UNITED STATES PATENT AND TRADEMARK OFFICE

APPLICATION NO.	FILING DATE	FIRST NAMED INVENTOR	ATTORNEY DOCKET NO.	CONFIRMATION NO.
09/578,391	05/25/2000	Akiro Sato	0694-132	6158

Office Action Summary

DETAILED ACTION

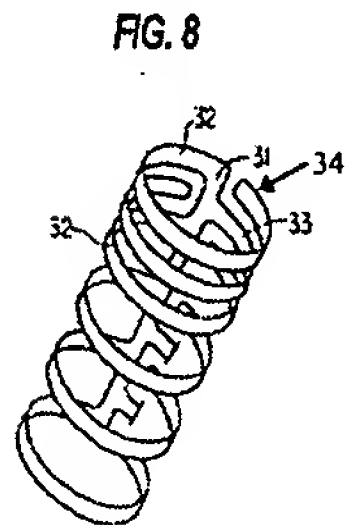
protrusions that Tessmann et al. teaches in 5167614, see figure 2. It would have been obvious to one skilled in the art at the time of the invention to place the protrusions detailed by Tessmann et al. onto the Schnepf-Pesch et al. device to help reduce the probability of the device from slipping.

3. Regarding claim 2, Schnepf-Pesch et al. teaches the use of a cylindrical device that would be inserted into a lumen during surgery (see figure 6.) He fails to teach that this device can be equipped with the protrusions that Tessmann et al. teaches in 5167614, see figure 2. It would have been obvious to one skilled in the art at the time of the invention to place the protrusions detailed by Tessmann et al. onto the Schnepf-Pesch et al. device to help reduce the probability of the device from slipping.

FIG. 8

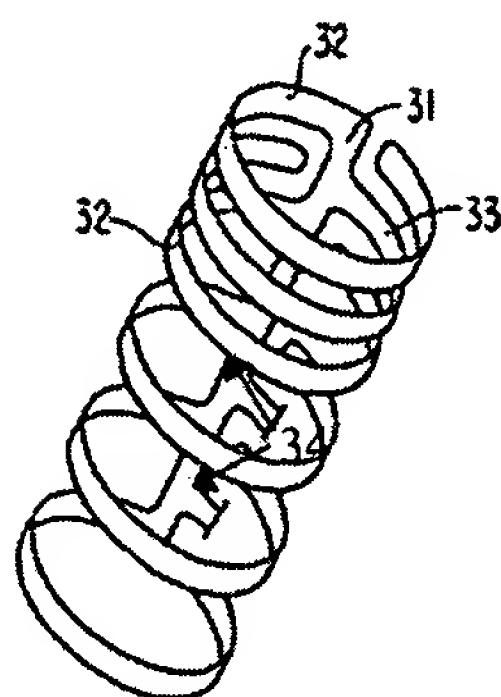
7. Regarding claim 9, Schnepp-Pesch et al. teaches a device with a plurality of plate members arranged in parallel with one another and containing a plurality of connecting members connecting said plate members with one another. (see figure 8.)

8. Regarding claim 10, the connecting members are made of an elastic, wire material. Item 34, in the below figure, points to two different wire members. Schnepp-Pesch et al. states that the shape can be a flat, metal sheet as illustrated, or the shape can be more similar to a round conventional wire in column 2, line 33. Finally, applicant should note that all metals could be considered elastic.
